City of Newton, Massachusetts

PUBLIC HEARING MEMORANDUM

SUBJECT: **Petition #312-23** for SPECIAL PERMIT/SITE PLAN APPROVAL to construct a storage warehouse for their tree removal business on the undersized lot which extends the nonconforming use and requires dimensional waivers at **0 Rumford**, Ward 4, Auburndale, on land known as Section 41 Block 35 Lot 12, containing approximately 8,302 sq. ft. of land in a district zoned MANUFACTURING. Ref: 7.3.3, 4.4.1, 7.8.2.C.2, 7.8.3.F.6, 7.8.3.B, 7.8.3.C, 5.1.8.D.1, 5.1.13, 5.1.8.D.2, 5.1.8.E.2 of Chapter 30 of the City of Newton Rev Zoning Ord, 2017.

ZONING REVIEW MEMORANDUM

Proposed elevations

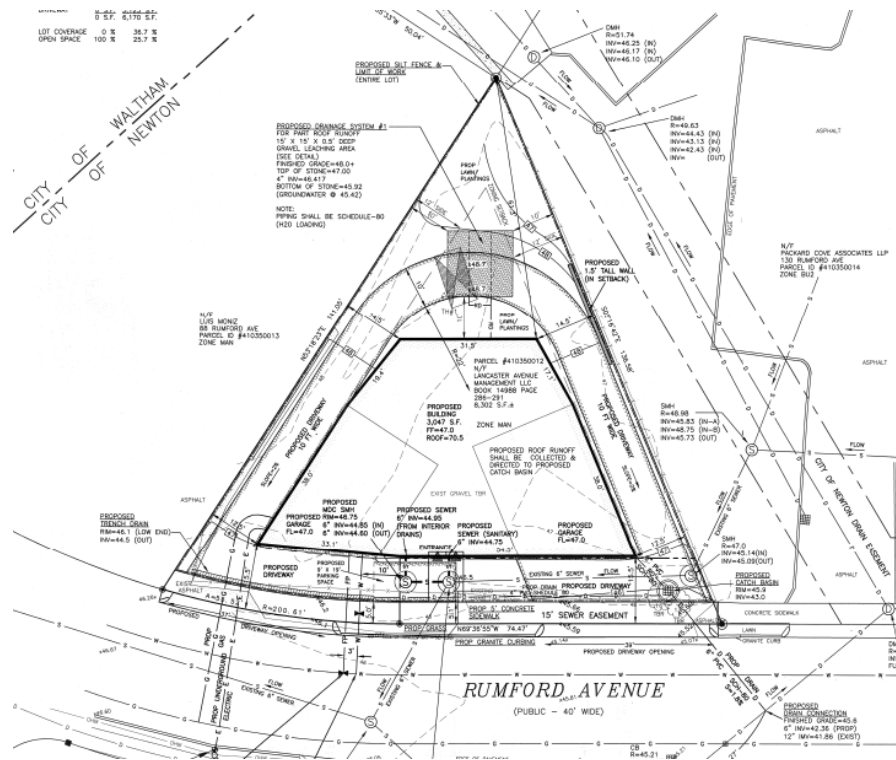
The Planning Department notes that the submitted architectural drawings do not include certain dimensions. Planning recommends that such information, consistent with that indicated on the proposed site plan, be submitted in advance of the issuance of any building permit issued pursuant to this petition.

Looking northly towards the rear of the lot.

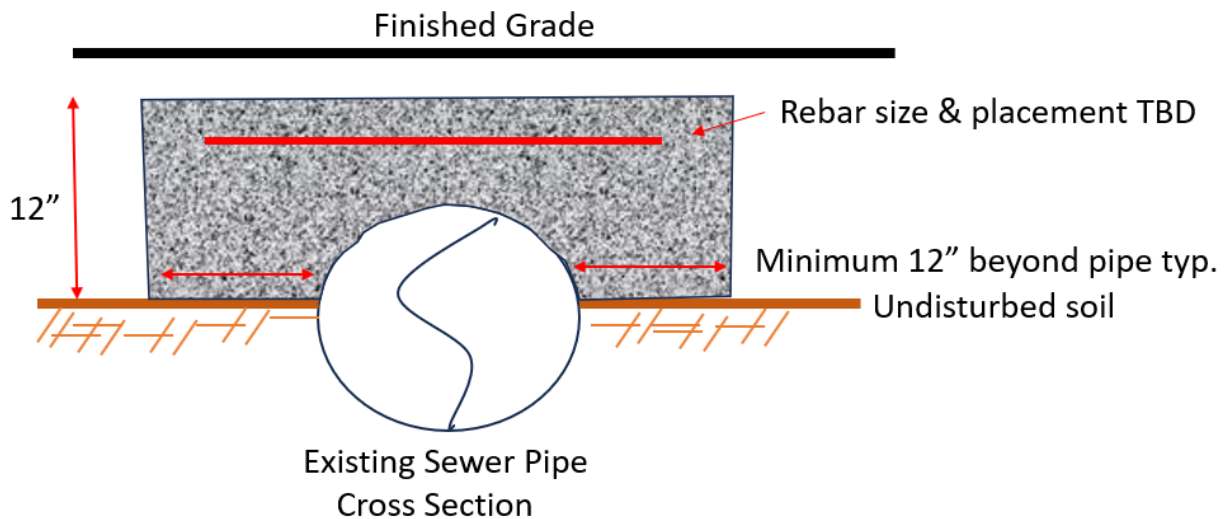
The frontage currently has no sidewalks nor curbing, the applicant is requesting two driveway curb cuts one is 37 feet wide towards the western side of the frontage and one at 39-feet on the east side of the frontage. The maximum driveway opening is 22 -feet per the City Construction Standards, however given the awkward shape of the lot the large construction trucks that will be garaged and accessing the lot, the two oversized aprons are reasonable; however, the DPW will insist that the concrete driveway aprons be 8-inches thick with rebar reinforcement due to the heavy loads imposed.

Additionally, the 15-foot-wide sanitary sewer easement and service pipe that transverses the frontage and proposed placement of the easterly driveway is cause for concern. The existing sewer pipe has just over 2 feet of over its length.

Prior to any construction the sewer service from the existing manhole at the south-east corner of the lot to the manhole in Rumford Avenue shall be inspected via a Closed Circuit Television (CCTV) Inspection to ensure that there is no damage to the pipe, the pipe then shall be fully exposed to the spring line and reinforced cement concrete shall be placed over the pipe for its entire length to ensure no future damage will occur to the pipe. (See sketch below). If the pipe is found to be damaged as determined by the City Inspector, the pipe shall be replaced with ductile iron pipe.

After construction of the site is completed this sewer pipe shall be re-inspected via CCTV to ensure no damage has occurred, if the pipe has been damaged then the applicant shall replace the pipe with ductile iron pipe.
